Letter: **ST-002-2018**

Subject: **Ignition control board defect**

Product: Residential single stage PSC gas furnaces.

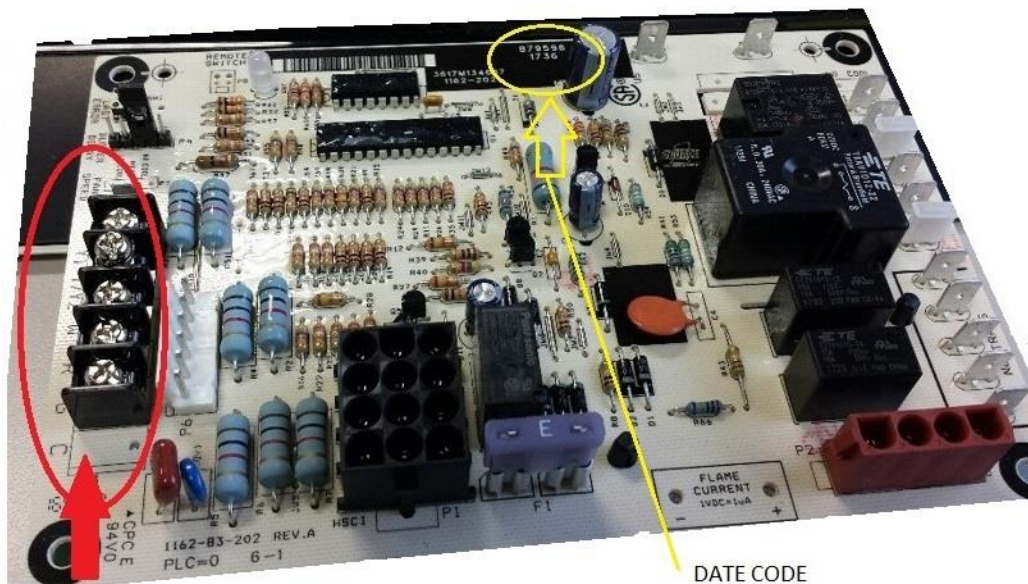
It was recently discovered that the control board low voltage terminal block has inadvertently been shifted over one space leaving the field wired COMMON connection to the control with no terminal to connect the field supplied thermostat wiring to. According to the control board manufacturer, the affected date code of the board is 1736. This defect is limited to a very small number of control boards. We have received reports of only **TWO** incidents to date of this defective board issue. Below is a photo of a defective board.

Note the red circle and arrow. This illustrates the missing 24VAC thermostat common connection. The location of control board date code is circled in yellow.

If a control board defect of this type is found, please report it to the Residential Distributor Support team as we will require the control be returned to us for vendor analysis. The control board can be replaced with S1-33103010000 and claim one hour labor using the standard unit warranty. If further information becomes available, it will be provided with an update to this letter.

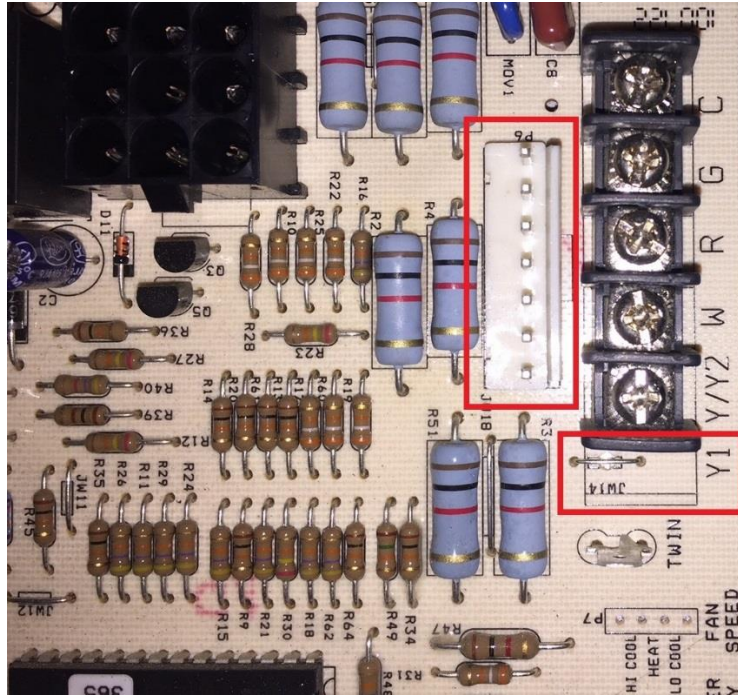
Note the red rectangle outline with the wire jumper inside it. It is labeled Y1. This is correct for the single stage PSC model control board.

Each and every furnace goes through a factory run test and must pass it prior to being packaged and shipped out. In the photo above there is a red rectangle outline around a plastic low voltage connection header labeled “P6.” The run test station on the assembly line connects to this P6 connector in lieu of connecting to the field thermostat wiring connection screw terminals. Since run test does not connect to the screw terminals, the furnace control was able to pass run test.
